RFI

RFI #: 175
Date: 7/27/2012
Job: EB-02 Keller Springs Lofts
Phone: 877-777-5115

Subject: Air handlers and CFM columns

SHEET NUMBER
M-2.3
A-3
A2-SP-UNIT MECHANICAL

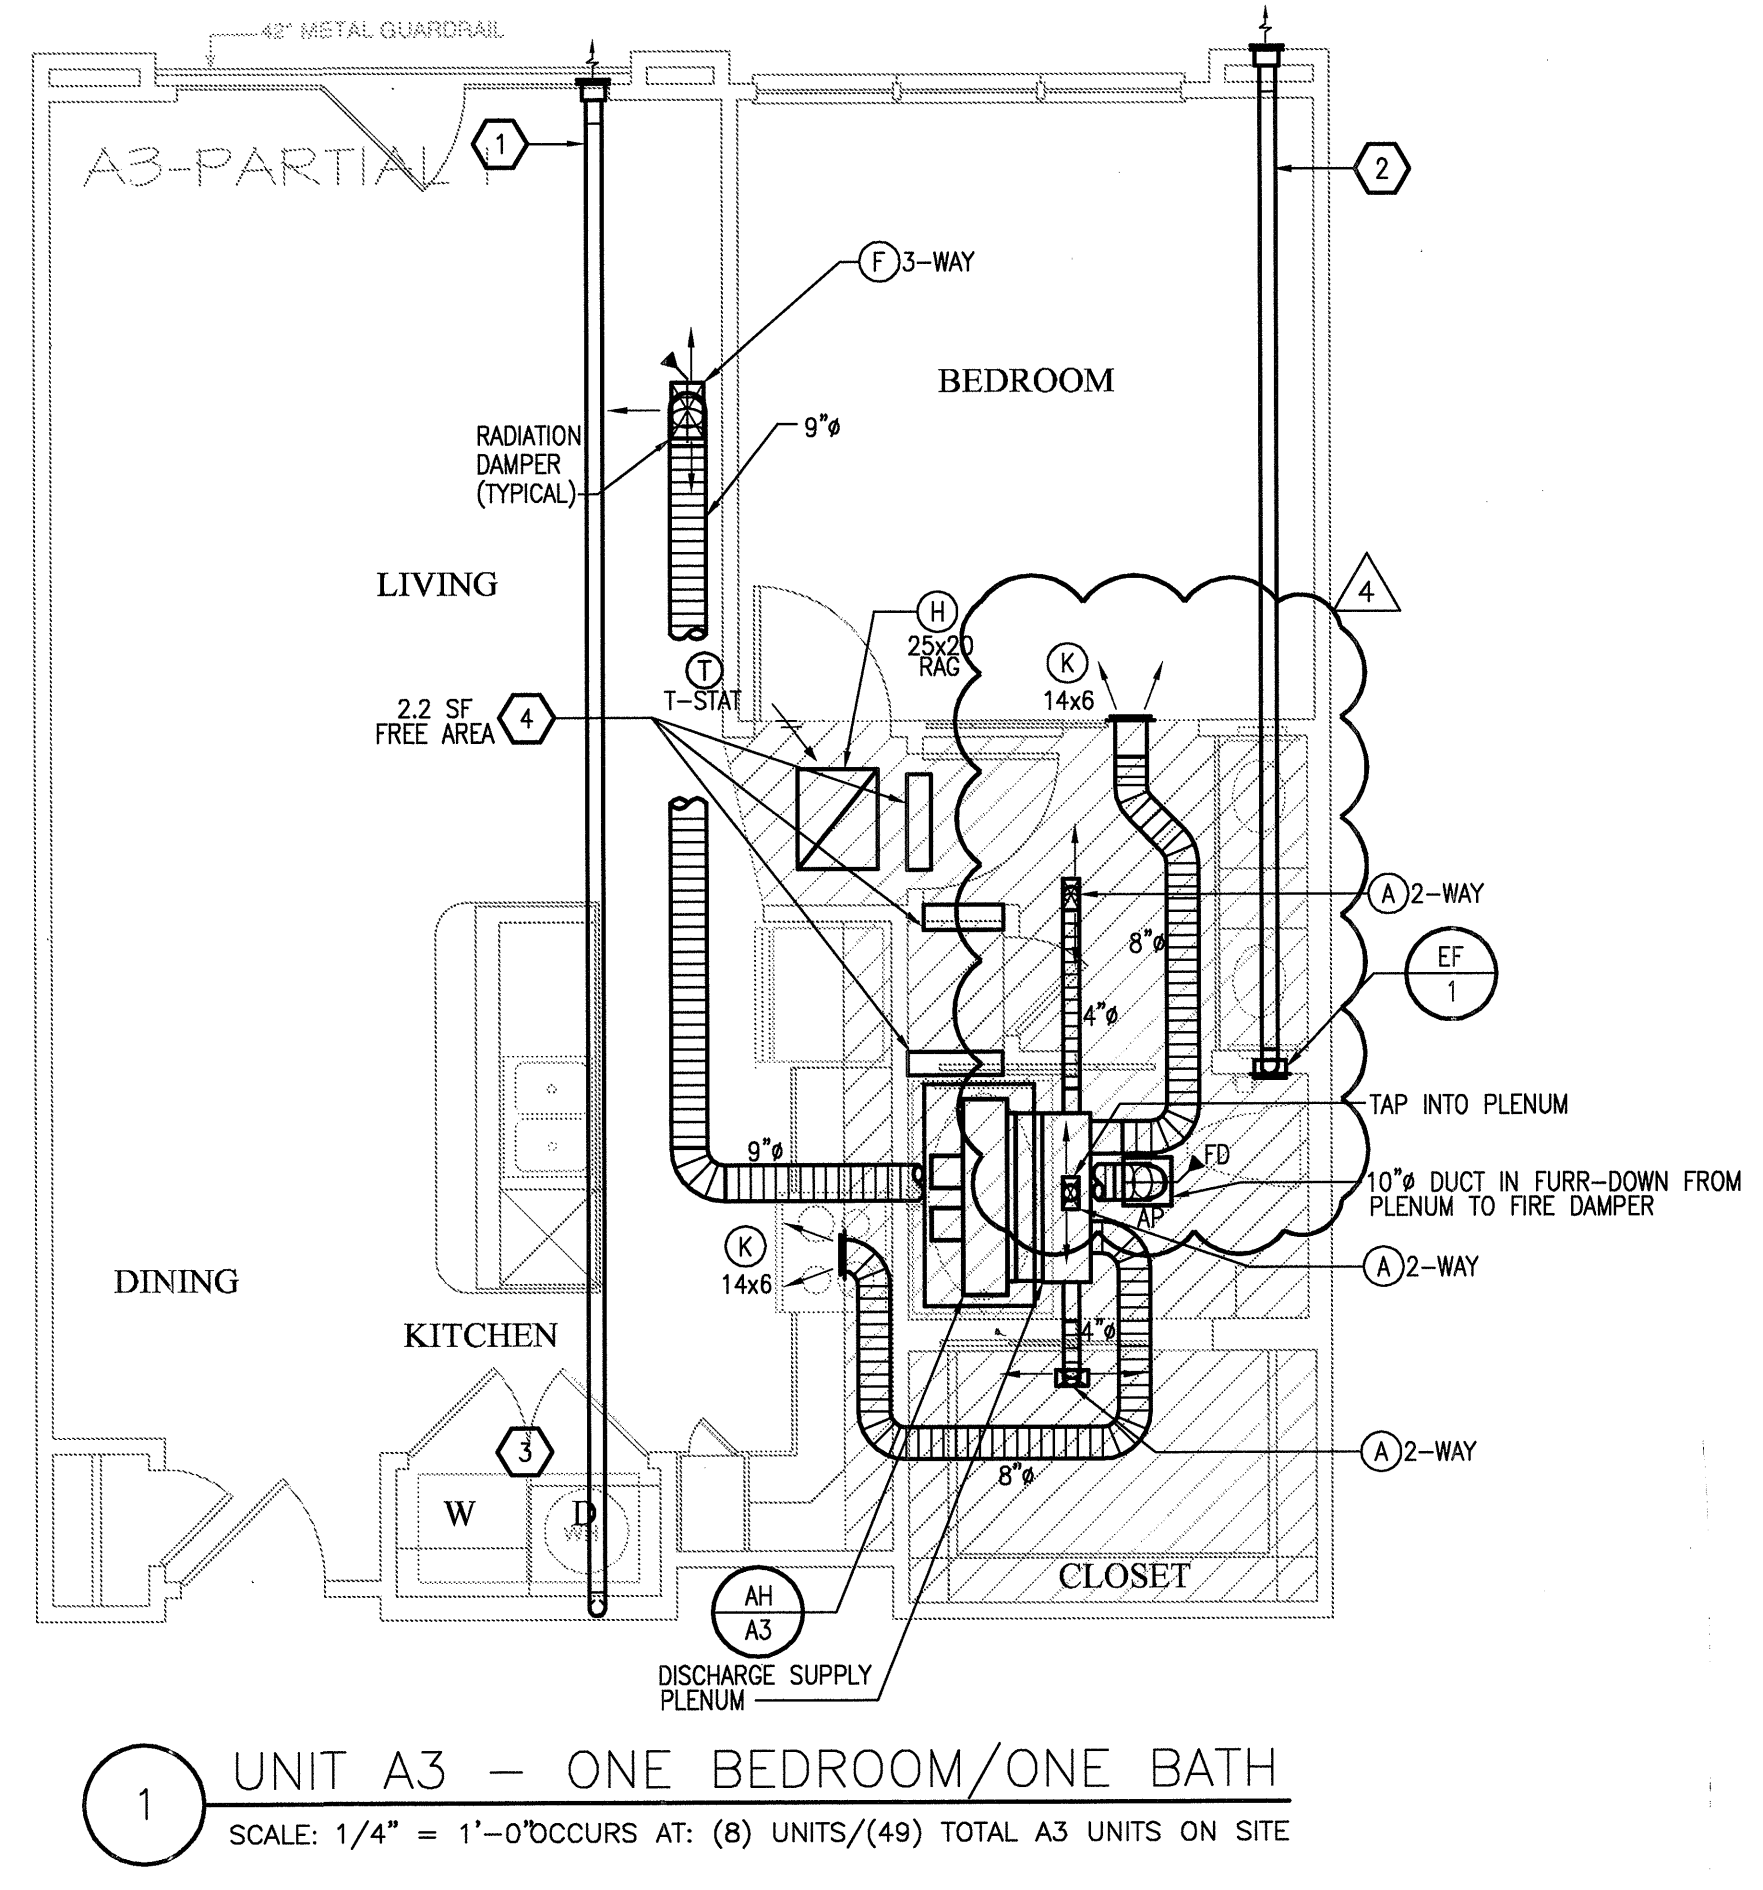
Request: **Date Required:** 6/22/2012
Sheet M-2.3 shows designation A2-SP unit but the floor plans designate an A3 unit. Please revise sheet M-2.3 to show the title A3 unit and not the A2-SP unit.

Response:
See attached for updated sheet title

SHEET NUMBER
M-2.11
A1-HC & BA-HC UNIT MECHANICAL

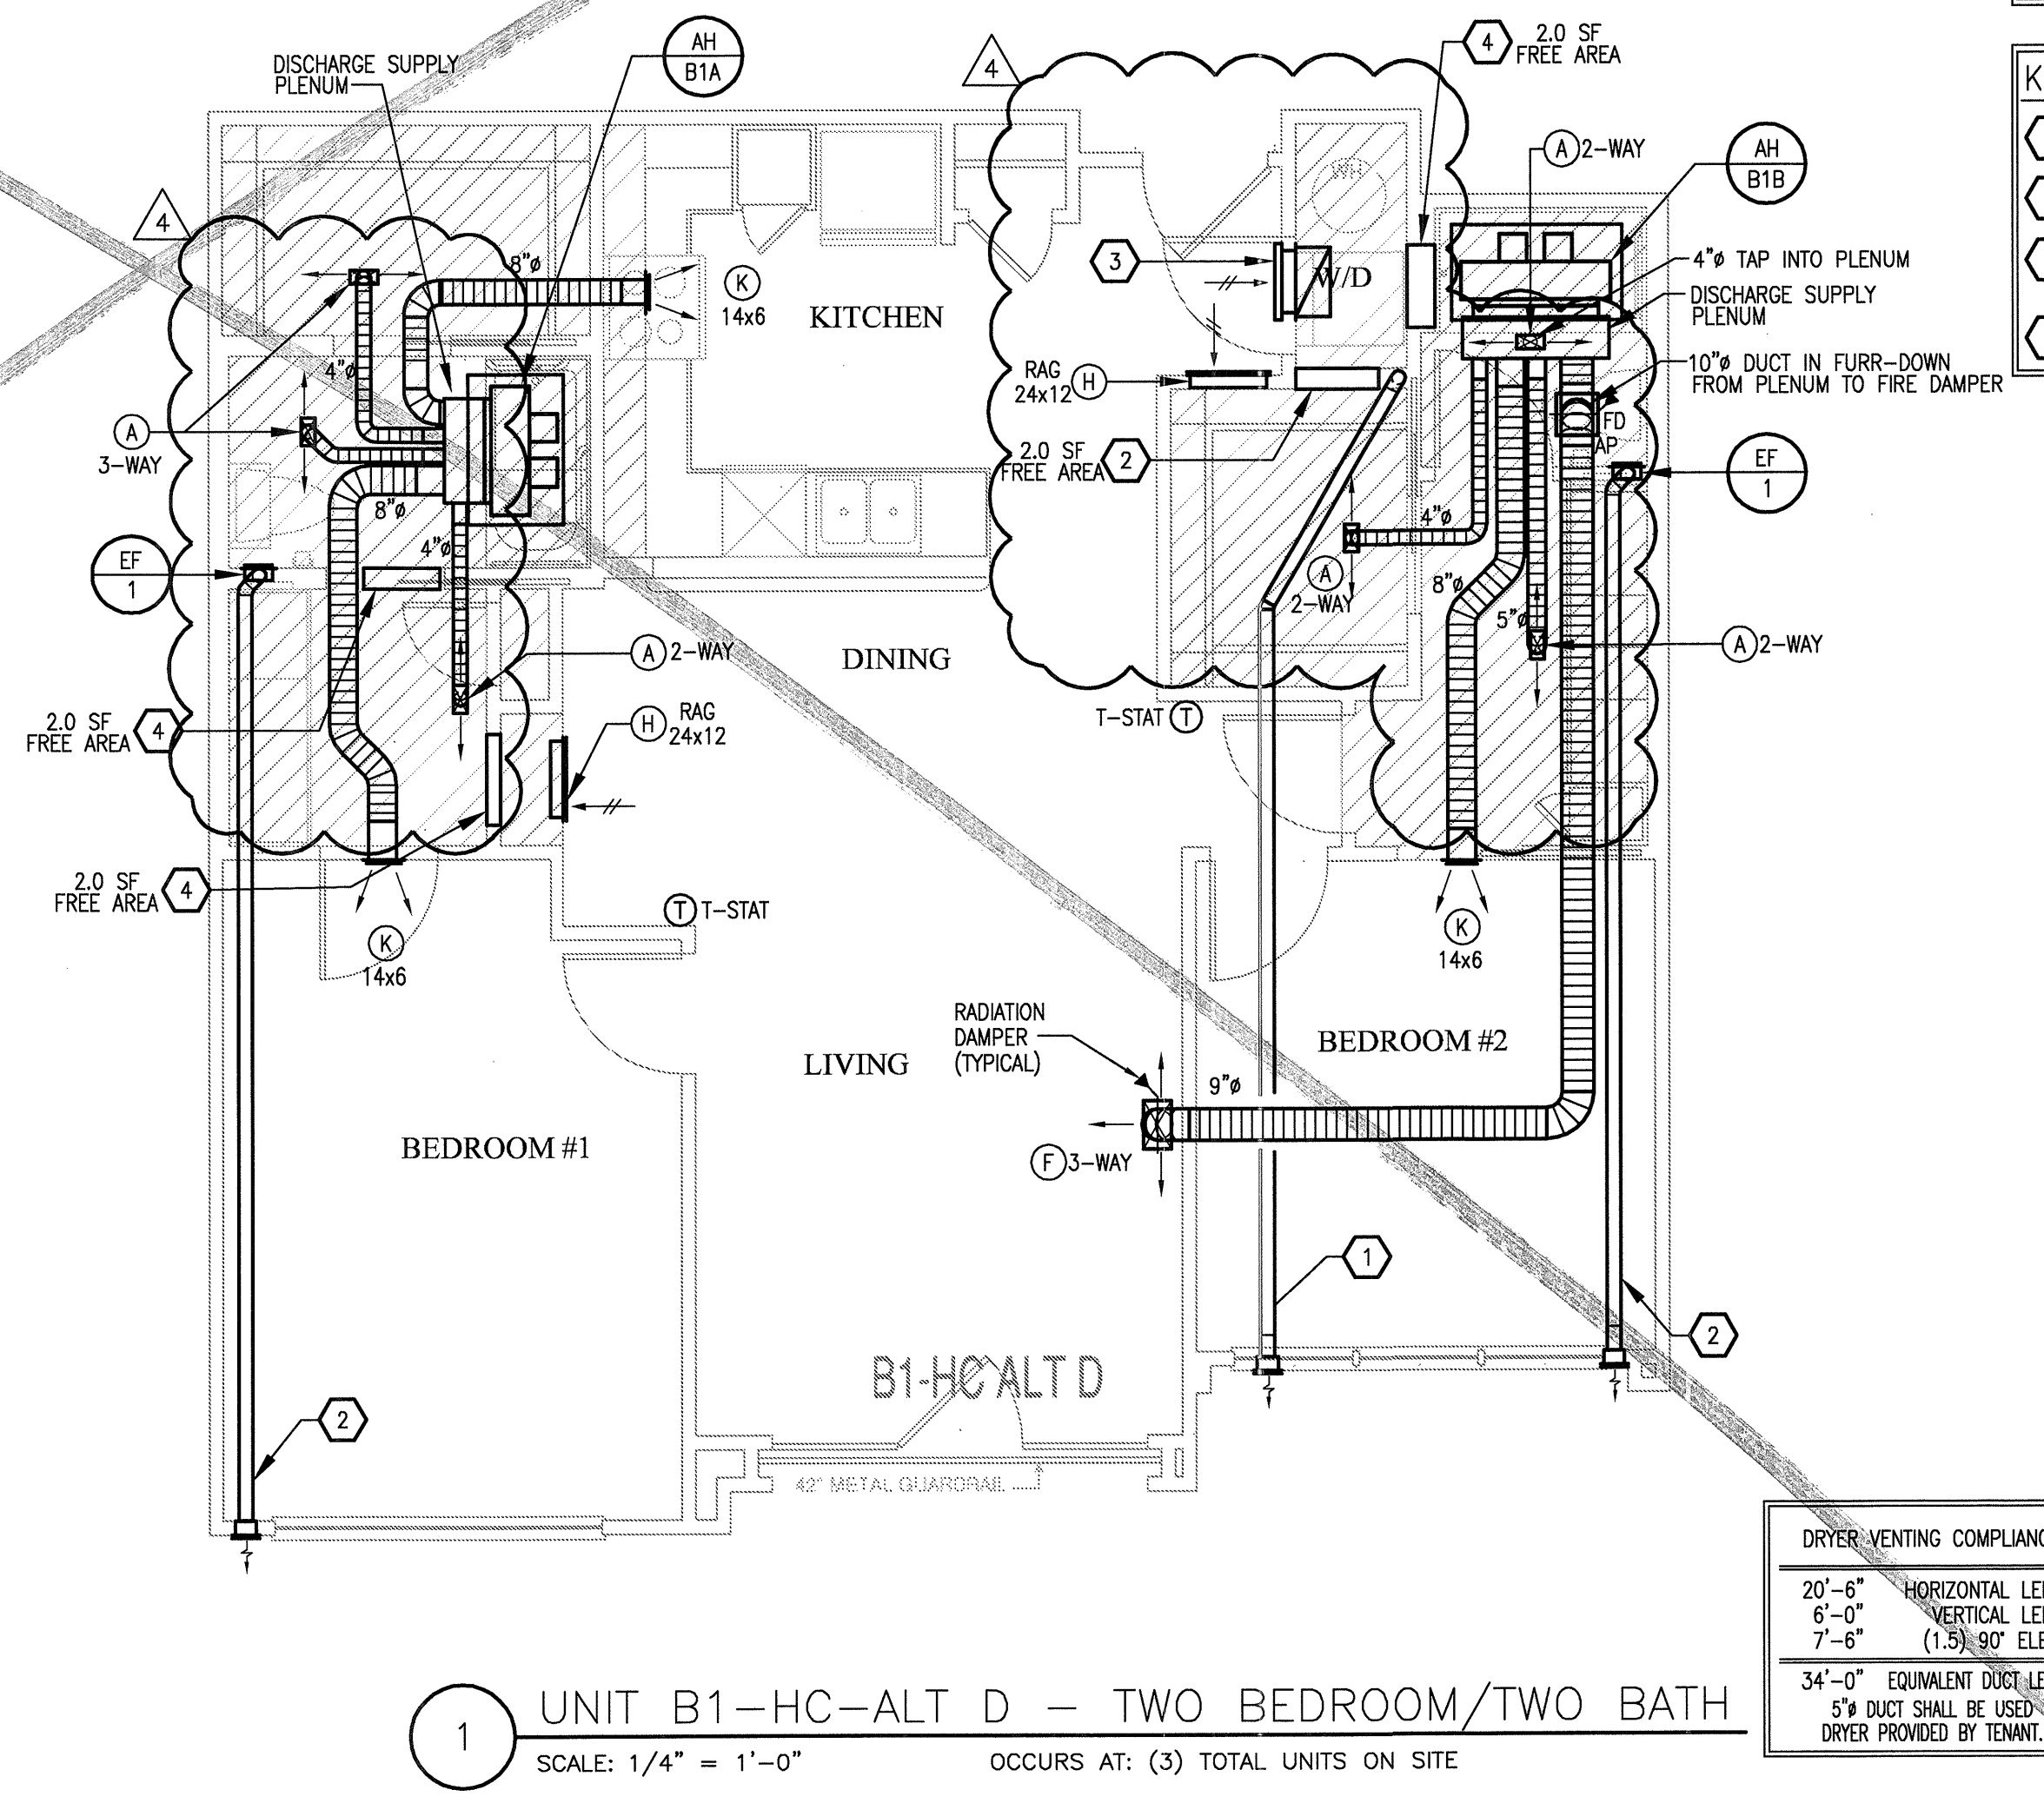
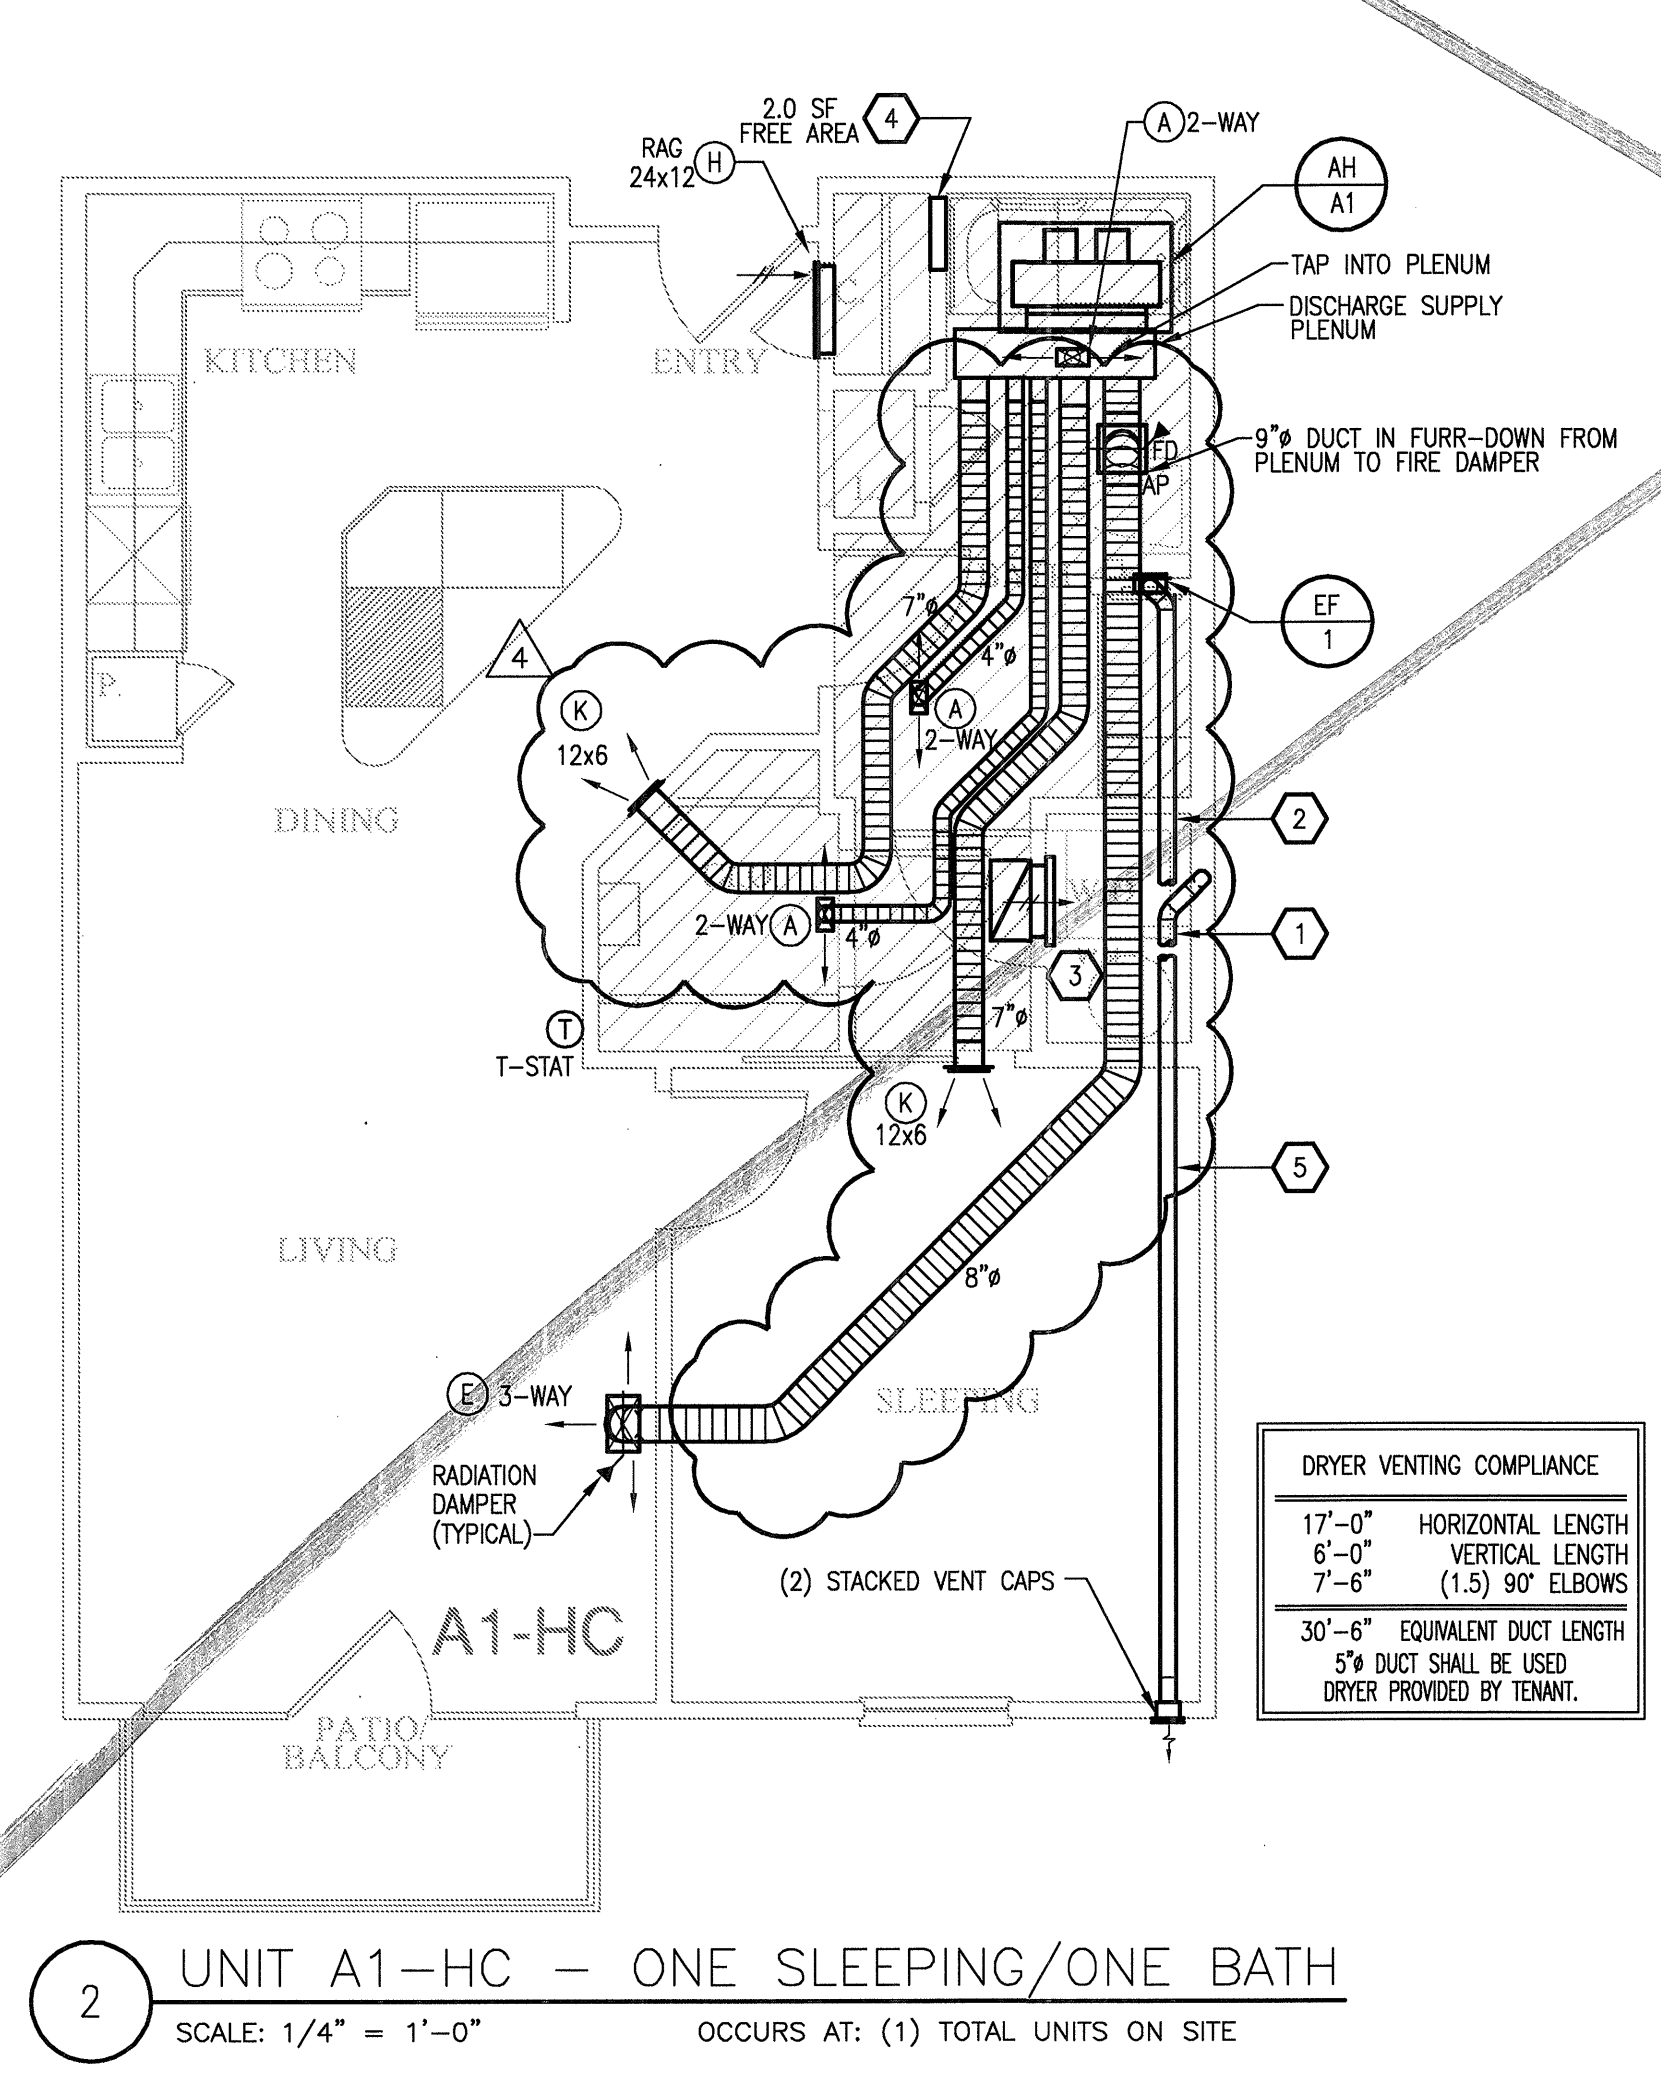
Request:
The B1-HC unit on sheet M2.11 has not been revised and doesn't match the floorplan of the B1-HC unit on A2.6HC. Please revise and reply.

Response:
See attached for updated plan
